**PLANNED UNIT DEVELOPMENT  
& SUBDIVISION STAFF REPORT****Date: June 21, 2018****DEVELOPMENT NAME**

Rangeline Crossing III Subdivision, Resubdivision of Lot 4A of the Resubdivision of Lots 4 &amp; 5

Planned Unit Development Approval to amend a previously approved Planned Unit Development to allow shared access between multiple lots and subdivision to create 2 lots from 1 existing lot.

# SITE PLAN

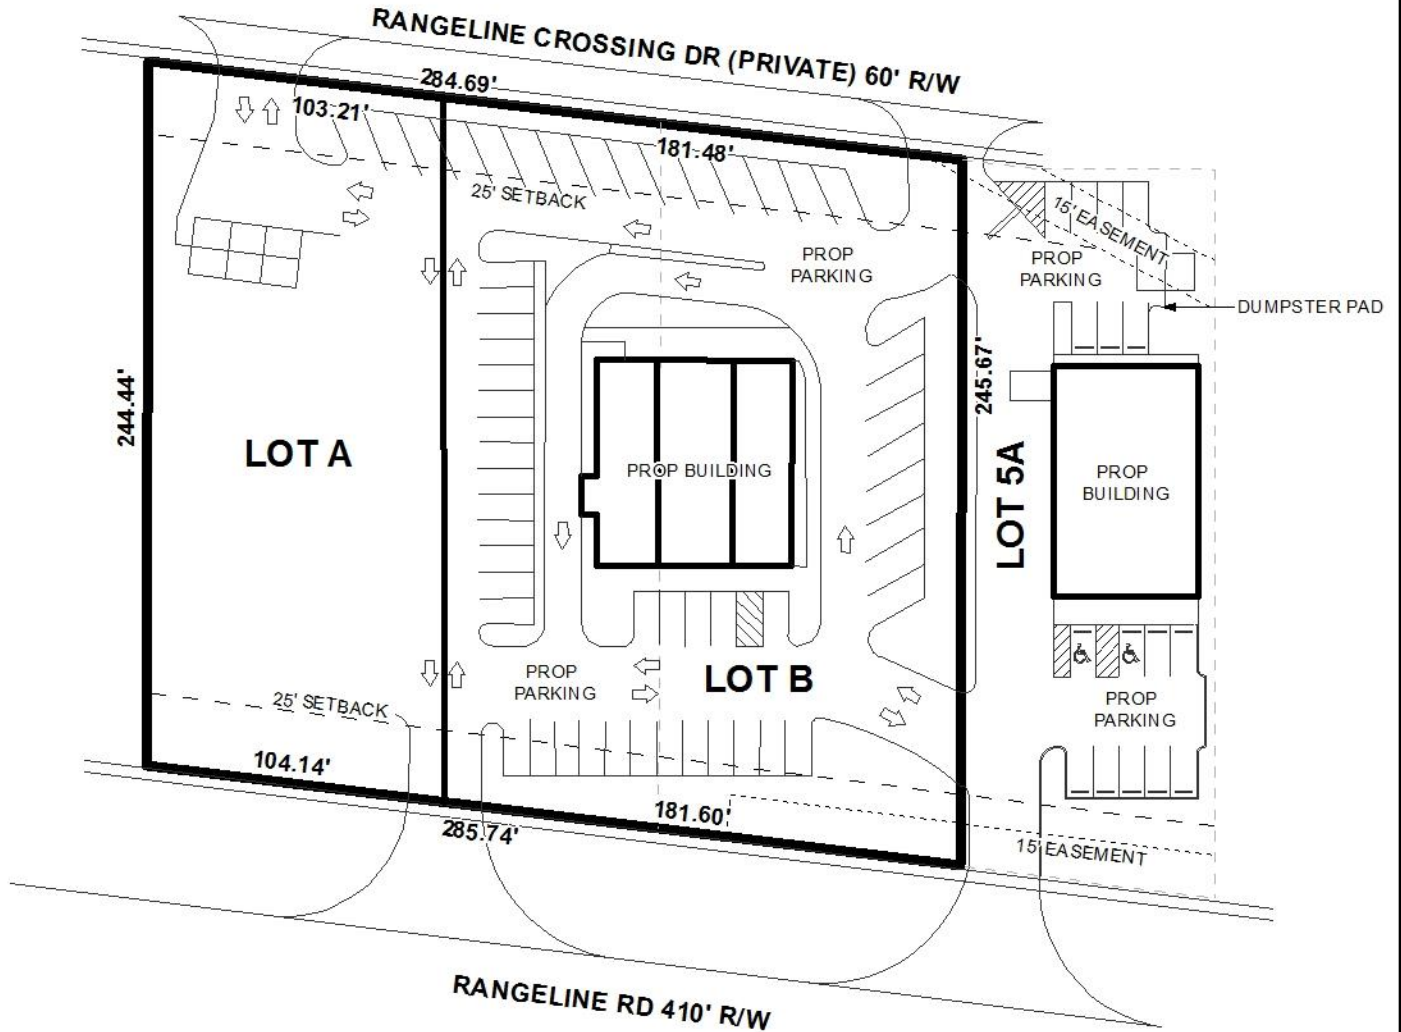
The PUD site plan depicts Lot A as being a 4,000 square foot "specialty retail store" and Lot B has having three tenant spaces totaling 4,700 square feet that will also be occupied as "specialty retail spaces"; however, on the above chart it is identified as restaurant and specialty retail. Lot B as proposed will have one 1,500 square foot tenant space, another tenant space will be 1,800

square feet, and the third tenant space will be 1,400 square feet. The site plan for Lot B depicts a drive thru lane, however no order station or stacking area are depicted. If a drive thru is proposed, it must comply with all requirements of Section 64-4.F. of the Zoning Ordinance.

It should be pointed out that there is no dumpster depicted on the site plan for Lot A or Lot B. The site plan should be revised to depict a dumpster or dumpster in compliance with Section 64-4.D.9., or note stating curb side pickup will be utilized.

The 25’ minimum building setback lines are depicted on the site plan and should be retained on any future site plans.

Several drainage, access and utility easements are depicted on the overall site and on the preliminary plat and the PUD site plan. The note stating “structures that are not associated with the purpose of the easement shall not be placed within any easement” should be retained on both the plat and site plan.

Sidewalks are depicted on the site plan and should be retained on any future plans.

It should also be pointed out that the PUD site plan depicts the proposed lots as Lot 4A and Lot 4B; however the preliminary plat depicts the lots as being Lot A and Lot B. The labeling of the lots should be revised to be the same on both the PUD site plan and the plat. The “site data table” and the site plan labels should also be revised to state the same proposed uses on the site plan table.

Based on the revisions to the PUD site plan, a revised Master Plan for the overall site will be required. The revised Master Plan site plan should reflect the new narrative which identifies the proposed tenants, square footage of each building/ tenant spaces, and the lot with the lot sizes in square feet and acres.
